AMENDMENTS TO THE DRAWINGS

App No.: 10/698,976

Title: FLEXIBLE VERSATILE LOW-COST

WIRELINE TRANSMIT DRIVER

FIG. 5

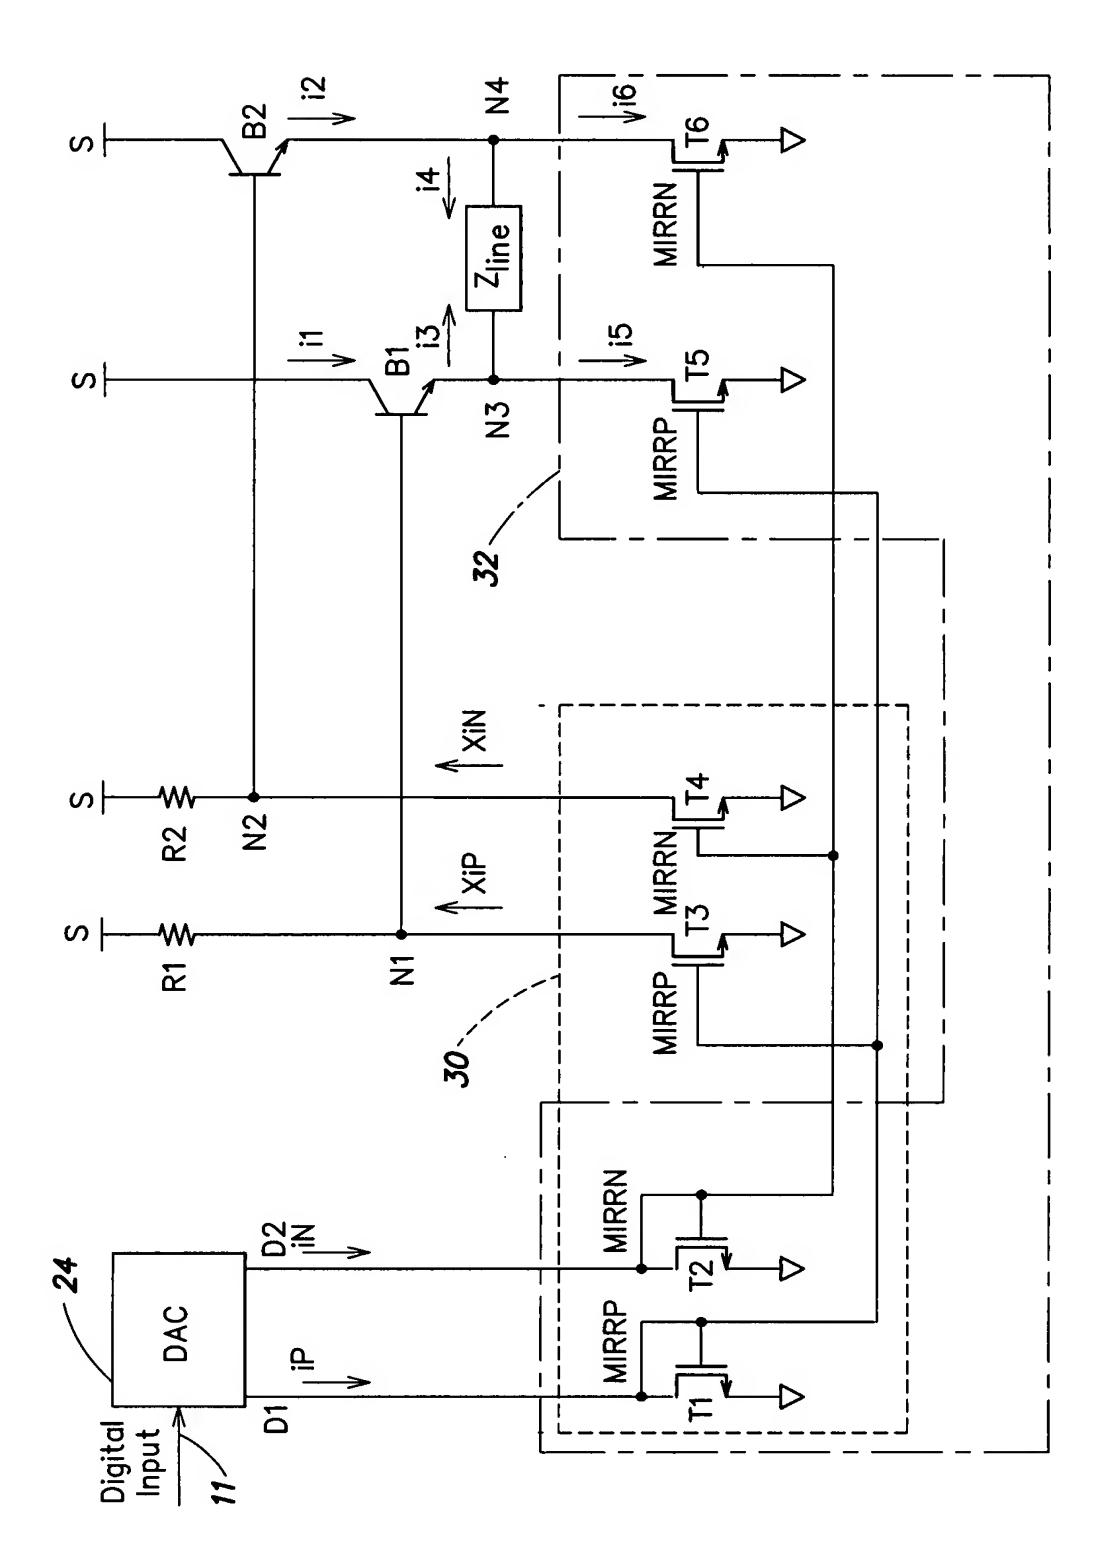
The Office Action objects to the drawings because the two current mirrors in figure 5 are allegedly unclear. Applicant has included herein a Replacement Sheet for FIG. 5. In the replacement sheet, the current mirror 30 and current mirror 32 are enclosed in respective differently patterned dotted lines to clearly distinguish the two current mirrors. The first dotted enclosure labeled as current mirror 30 encloses transistors T1, T2, T3 and T4 as described on page 5, lines 22

and 23 of Applicant's Specification. The second dotted enclosure labeled as current mirror 32 encloses transistors T1, T2, T5 and T6 as also described on page 5, lines 22 and 23. The two differently patterned dotted enclosures added in the Replacement Sheet now clearly illustrate grouping of transistors forming current mirror 30 and current mirror 32, respectively, as described in the Specification. Thus, Applicant respectfully requests that the objection to the drawings be withdrawn.

Please replace FIG. 5 with the Replacement Sheet attached herein.
